SUBJECT: Record of Decision for the Purity Oil Sales Superfund Site

RECORD OF DECISION

PURITY OIL SALES, INC.

Soils Operable Unit

Figure 5: RCRA Equivalent Cap

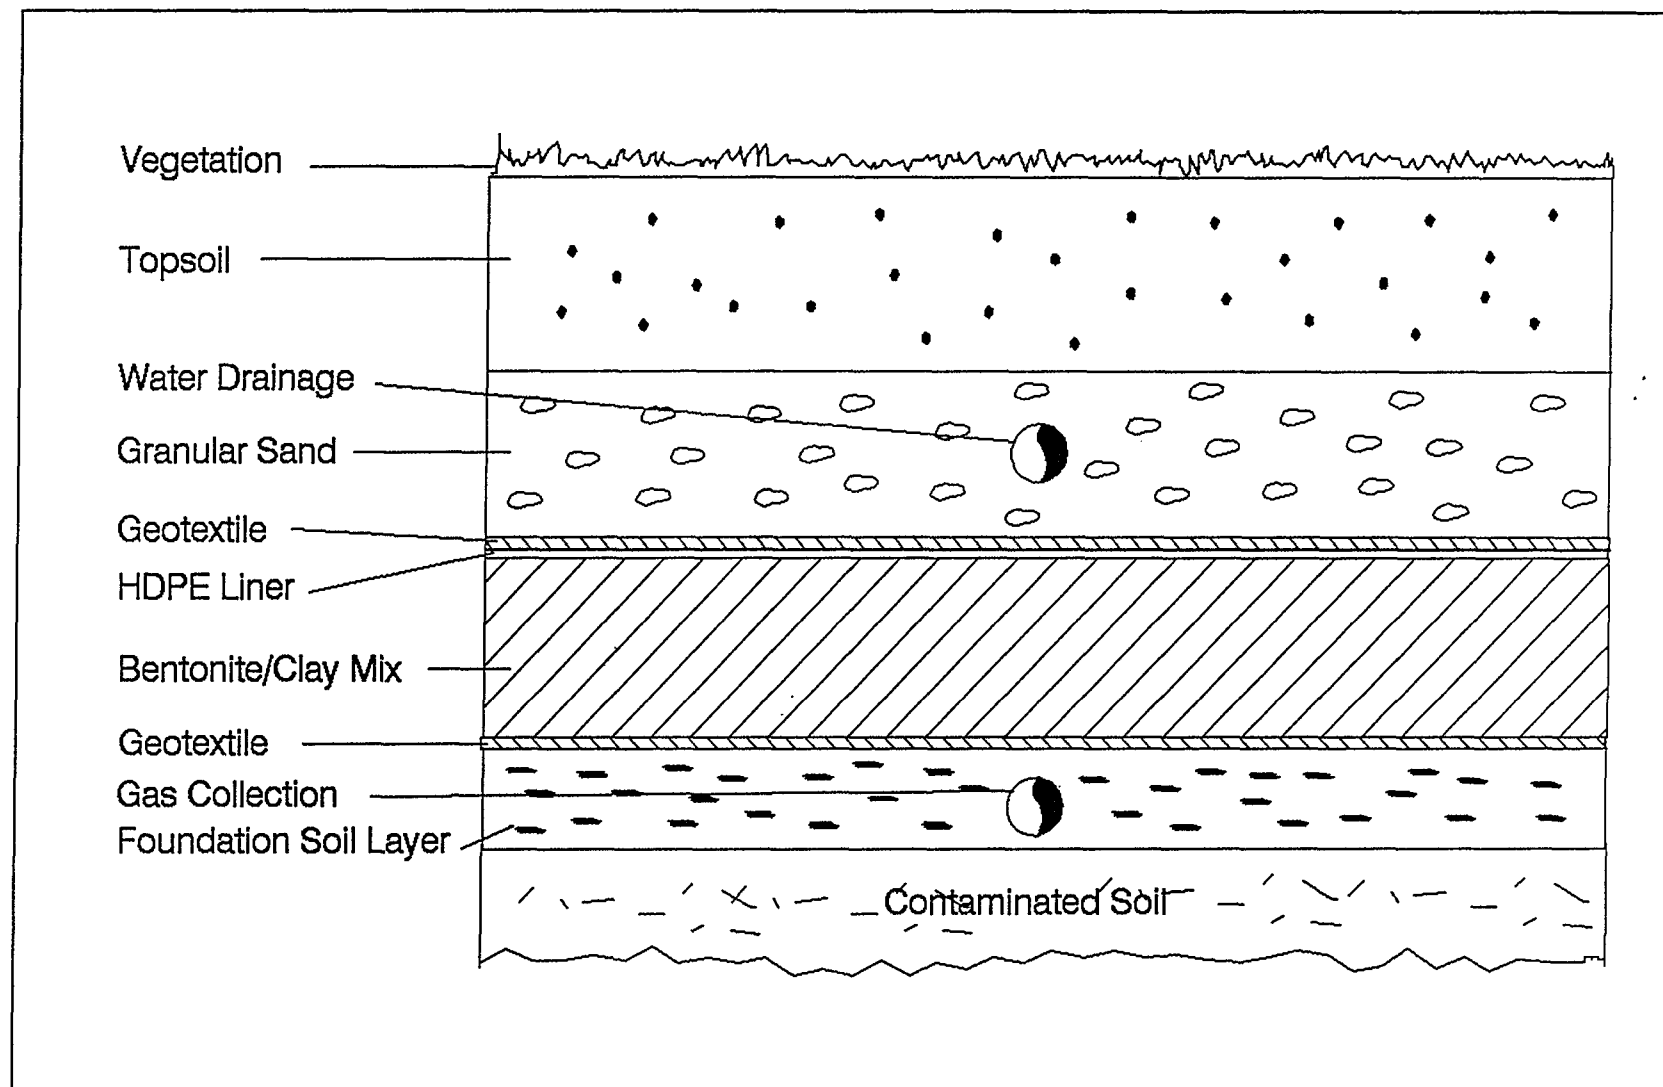
The Proposed Plan includes a diagram of the "RCRA equivalent cap". The figure does not contain specifications as the thicknesses of the various layers and materials. The May 1992 "Revised Soil Vapor Extraction and Cap Feasibility Study" contains some specifications but the thickness of the HPDE layer is not stated. At a minimum, the cap should conform to the requirements of the EPA guidance document entitled "Final Covers on Hazardous Waste Landfills and Surface Impoundments" dated July 1989 (EPA/530-SW-89-047).

Figure 2: SOIL VAPOR EXTRACTION SYSTEM

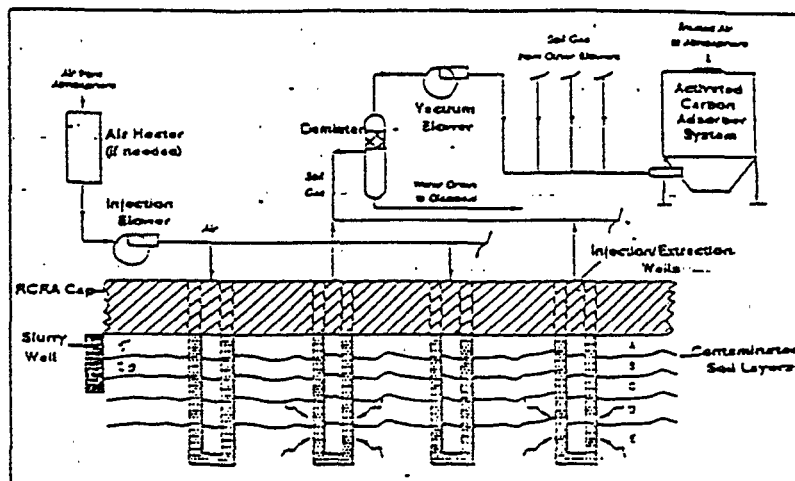
soil vapor extraction for soils at 14-40 feet. The portion of the proposed plan which describes the soil extraction system is reproduced below:

extraction and the amount of VOCs from layers A and B which will be collected are unknowns. Hence, the methodology used to estimate the period of operation is not suitable for determining the point at which the operation of the SVE system should be discontinued and the SVE wells removed.
